Duquesne Light Company
(Beaver Valley Power Station, Unit No. 1)

APPLICATION FOR AMENDMENT
INSERVICE INSPECTION REQUIREMENTS

Requests for Relief from Hydrostatic
Inservice Inspection Requirements

Attachment D.1

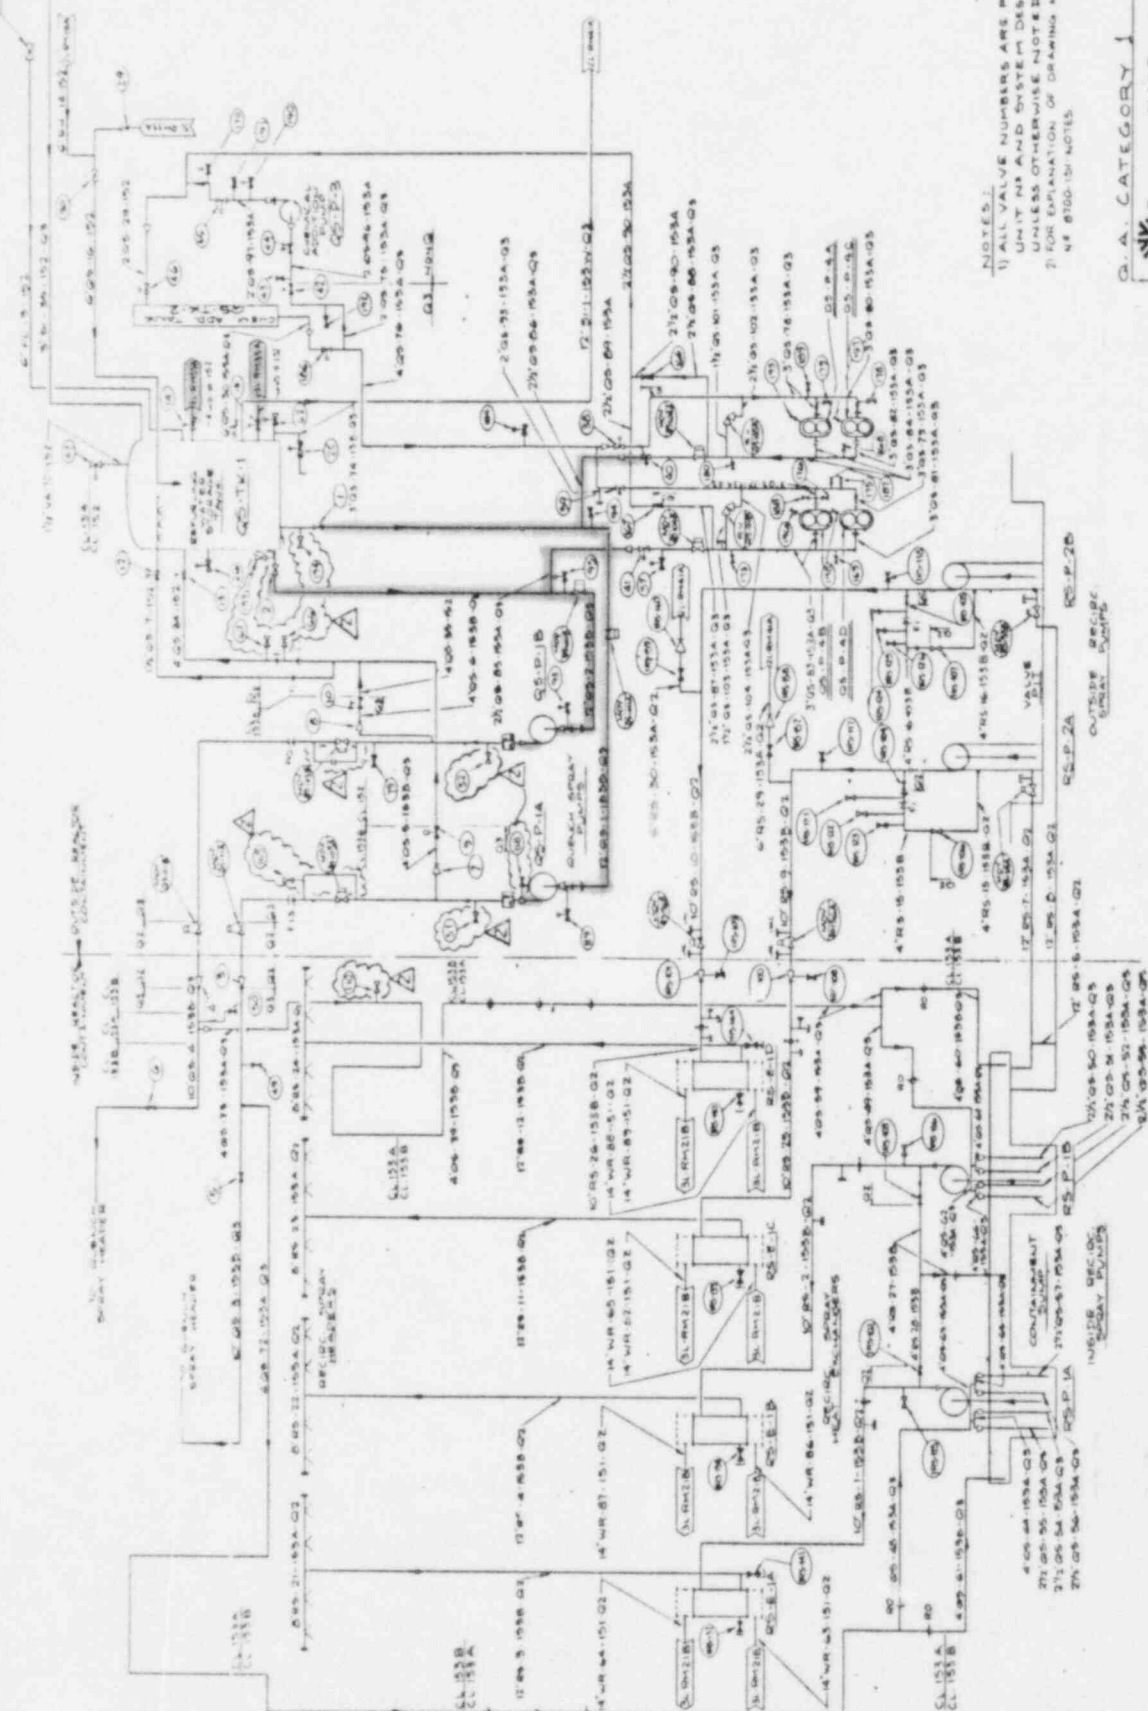
The following sections of Class 2 piping are affected (see Attachment C.1 drawings):

- (a) Cold leg injection lines between valves SI-97 and SI-100, SI-98 and SI-101, and SI-99 and SI-102.
- (b) Cold leg injection lines between valve MOV-SI-890C and valves SI-10, SI-11, and SI-12.
- (c) Hot leg injection lines between valve MOV-SI-890A and valves SI-15, SI-16, and SI-17 and between valve MOV-SI-890B and valves SI-15, SI-16, and SI-17.
- (d) Hot leg injection lines between valve MOV-SI-869A and valve SI-83 and between valve MOV-SI-869B and valve SI-84.
- (e) Safety Injection Accumulator lines:
 - 1. From valve MOV-SI-865A to valves MOV-SI-850A and SI-48.
 - 2. From valve MOV-SI-865B to valves MOV-SI-850C and SI-49.
 - 3. From valve MOV-SI-865C to valves MOV-SI-850E and SI-50.

The lines noted above cannot be isolated from the reactor coolant system if the Class 2 hydrostatic test pressure is applied. Hydrostatic testing of these lines to the Class 2 test pressure would overpressurize the reactor coolant system.

These portions of Class 2 piping will be hydrostatic tested at the reactor coolant system test pressure (1.02 Po). Vent and drain valves will be utilized as jumpers past check valves to allow pressurization of the Class 2 piping.

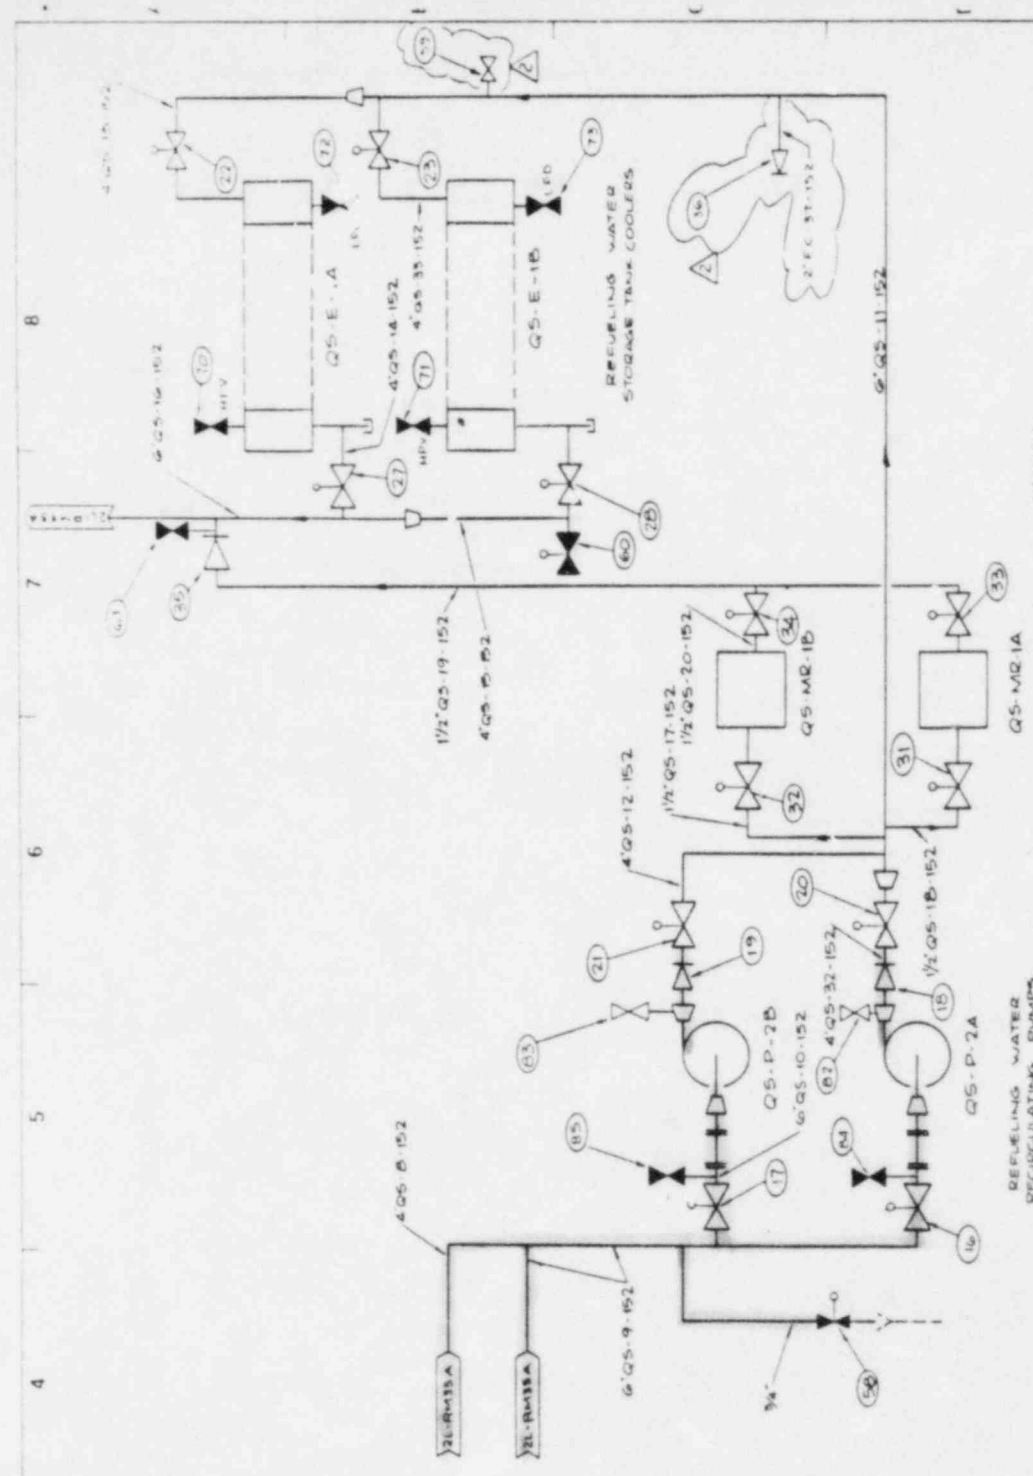
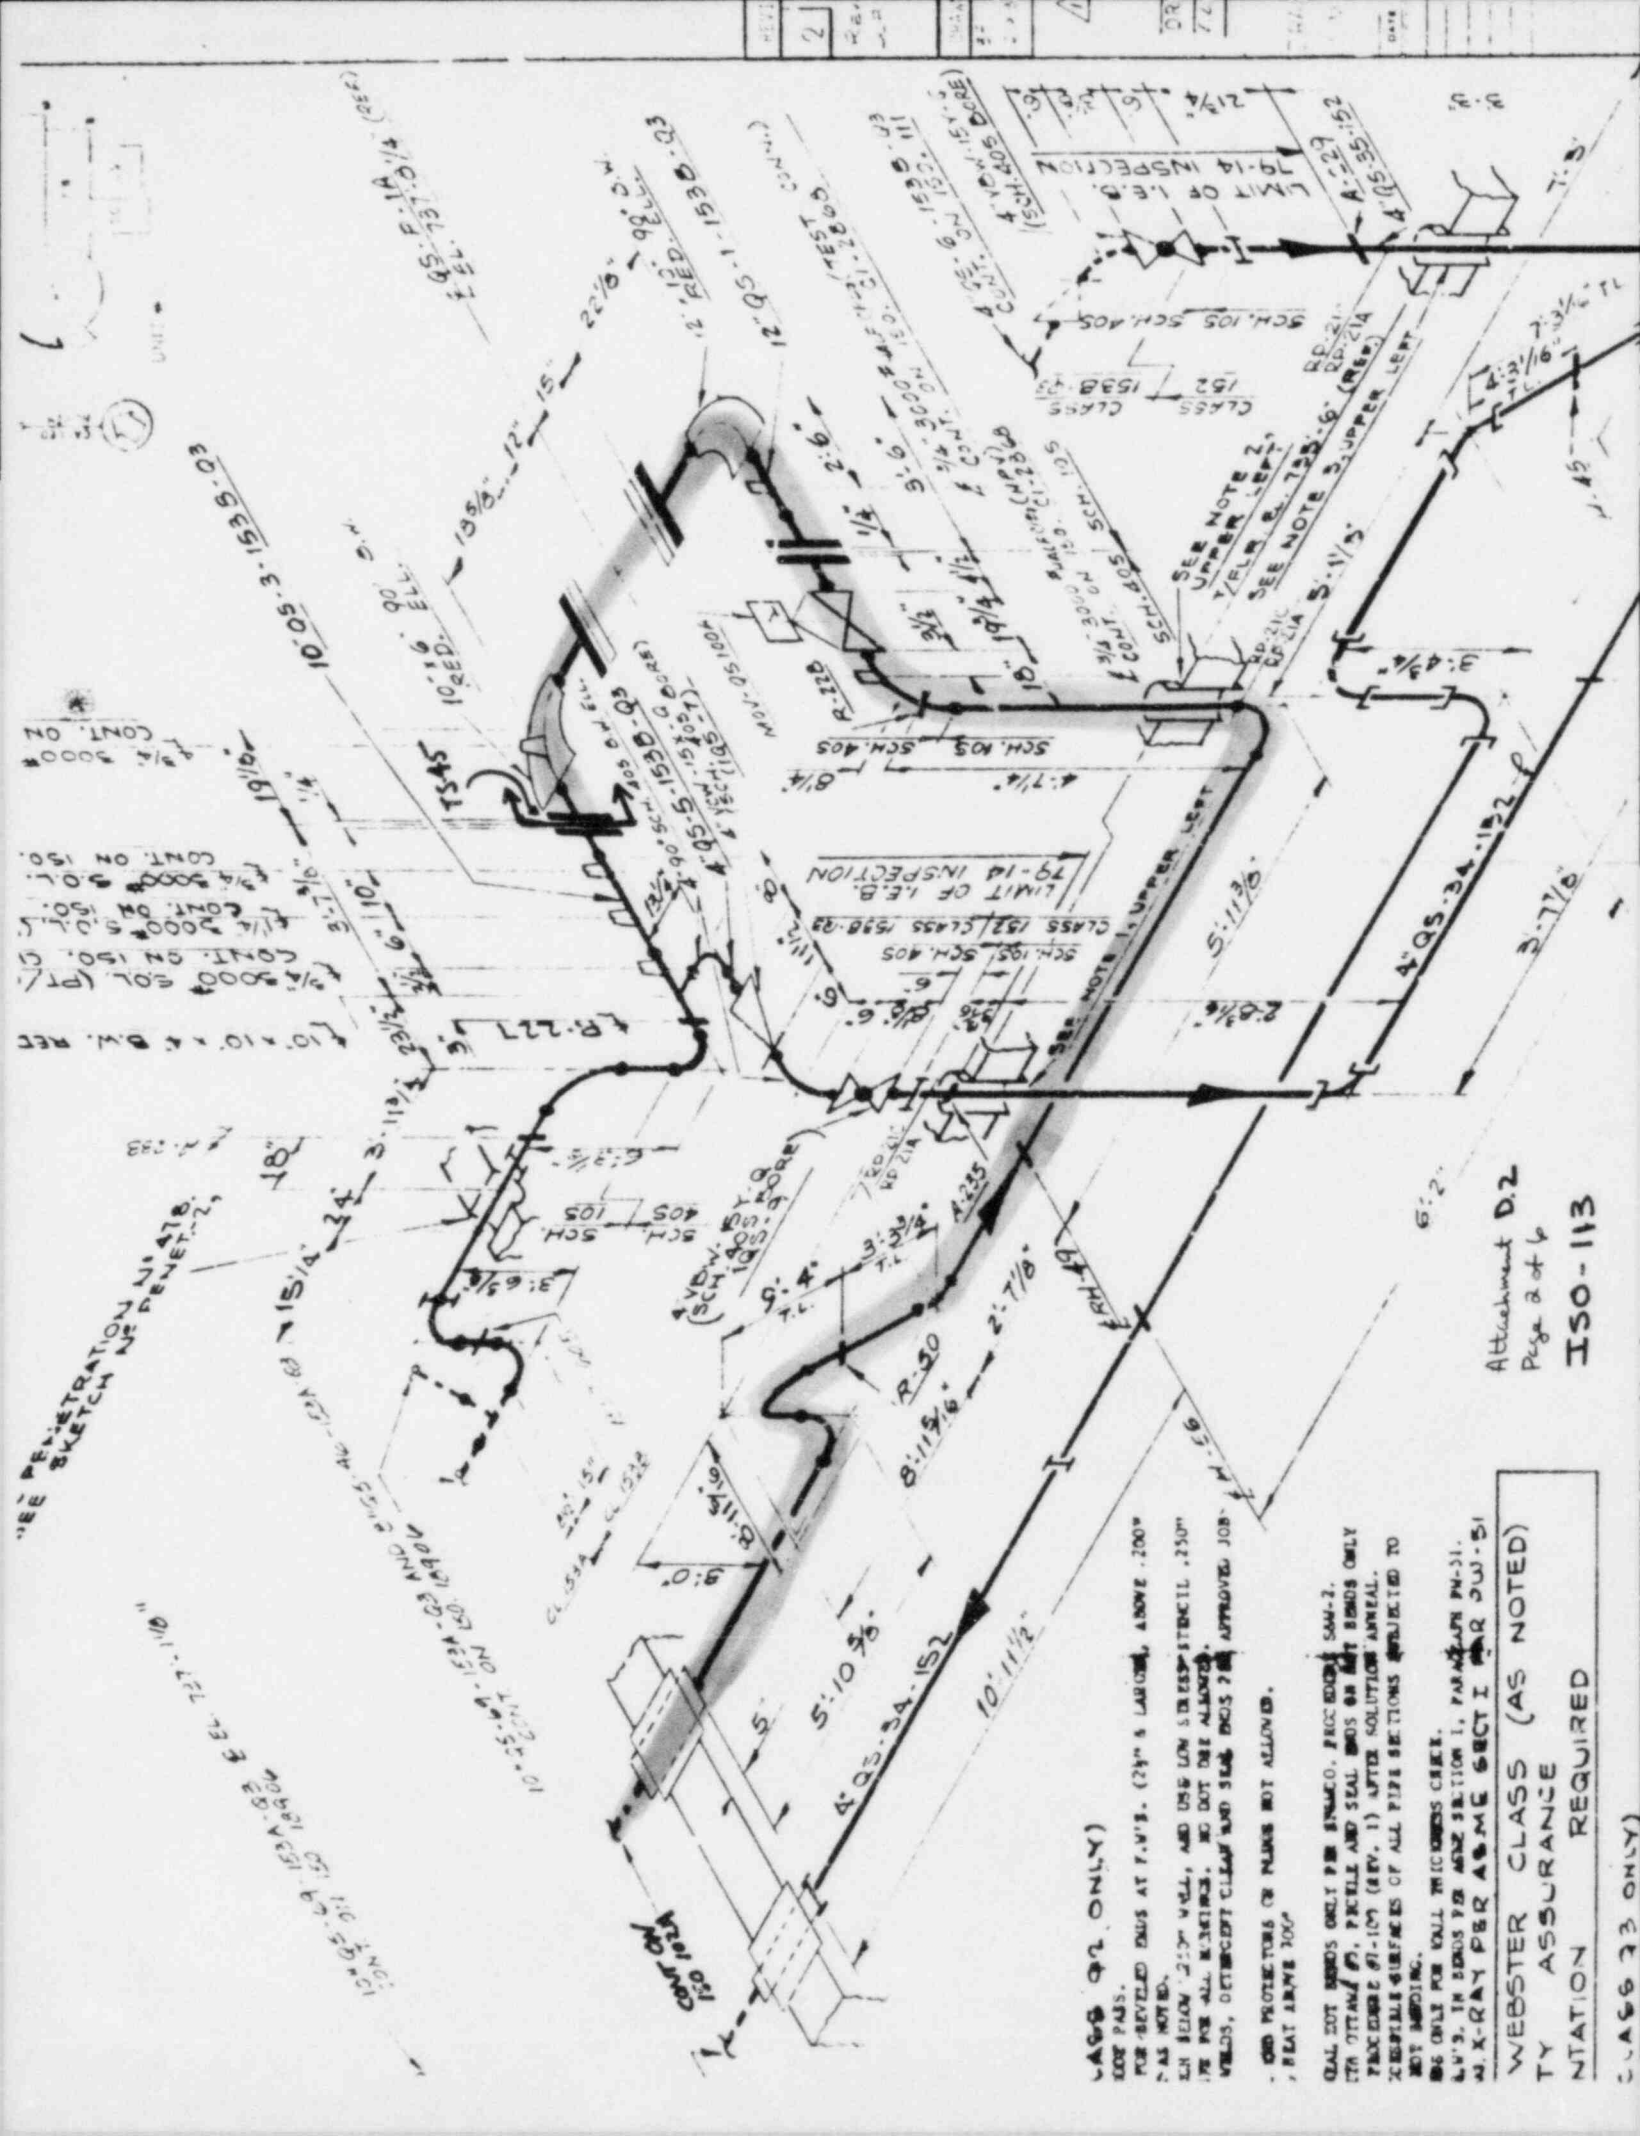
The following sections of Class 2 Quench Spray System piping are affected (see Attachment D.1 and D.2 drawings):

- (a) 1A Quench Spray Pump piping from valve QS-1 to Temporary Strainer (TS45) and to valve QS-40.
- (b) 1B Quench Spray Pump piping from valve QS-2 to TS-46 and to valve QS-41.

The design pressure of the affected piping is 20 psig. In accordance with IWC-5222(a) and IWD-5222(a) the hydrostatic test pressure would be 22 psig. Using the static head developed by the maximum level (elev. 787'6") in the Refueling Water Storage Tank (RWST) as the hydrostatic test pressure would apply the code required test pressure (at least 1.1 Pd) to the majority of the test boundary. The high point of the test boundary (elev 740'7") would be at a pressure of 20.3 psig, still above the design pressure rating of the system but below the code required test pressure of 22 psig.

The portion of the Quench Spray System noted above will be examined during hydrostatic testing using the static head of the maximum level of the RWST as the hydrostatic test pressure.
